Planning Application 2019-11-CON

Beacon Interfaith Housing Collaborative Multiple Family Housing Concept Plan Review

RE: **COMPLIANCE WITH MIXED USE DEVELOPMENT STANDARDS & DOWNTOWN OVERLAY DISTRICT**

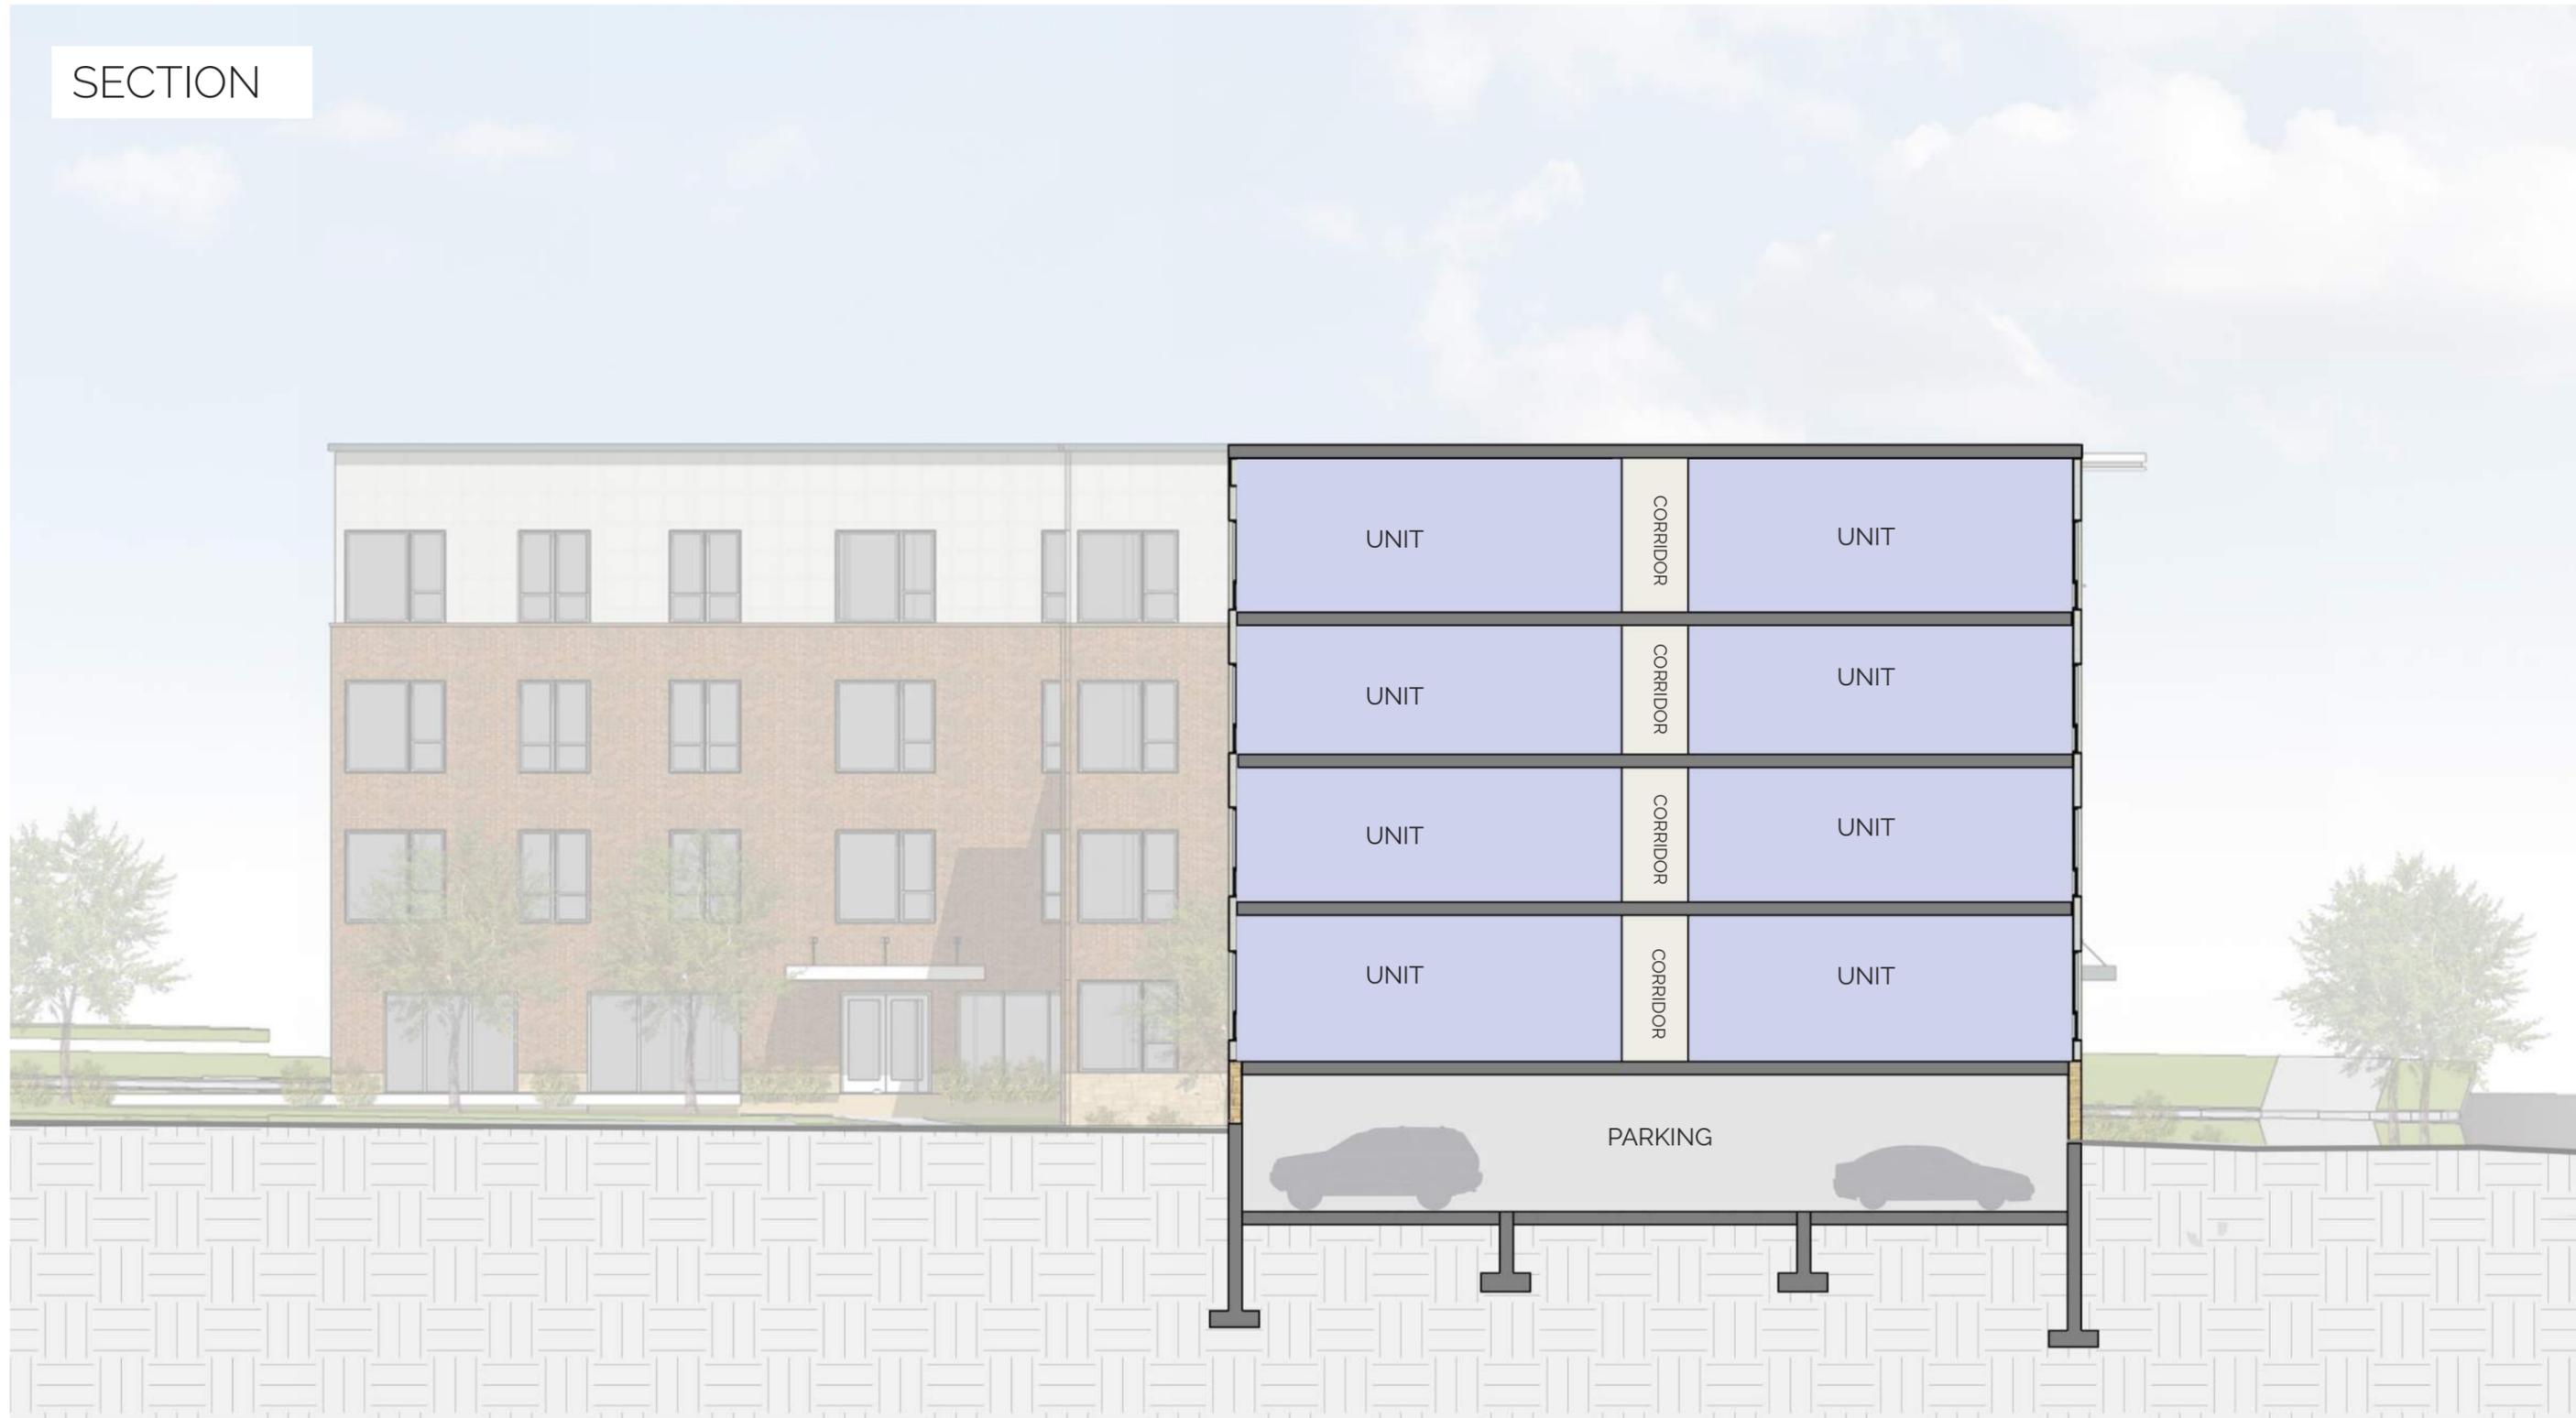
Exterior. The Mixed Use district requires the primary exterior treatment of walls facing a public right-of-way or parking lot on a structure shall be brick, cast concrete, stone, marble or other material similar in appearance and durability. Regular or decorative concrete block, float finish stucco, EIFS-type stucco, cementitious fiberboard, or wood clapboard may be used on the front façade as a secondary treatment or trim but shall not be a primary exterior treatment of a wall facing a public right-of-way. Staff defines primary as at least 80% of the wall while secondary could be up to 20% of the wall. As illustrated on the attached building elevations, the building fails to meet the exterior materials standards. The plans show the building is 53.8% brick on the north elevation, 25% brick on the south elevation, 54.3% brick on the east elevation and 50% brick on the west elevation. Staff recommends the applicant revise their plans to meet the minimum 80% primary and 20% secondary materials requirement.

Façade. The primary street side façade of a building shall not consist of an unarticulated blank wall, flat front facades or an unbroken series of garage doors. The front of a building shall be broken up into individual bays of a minimum of 25 feet and maximum of 40 feet wide. The concept plan fails to meet this standard on any side of the building. The south side of the buildings has breaks of more than 60 feet while the east and west sides have breaks exceeding 70 feet.
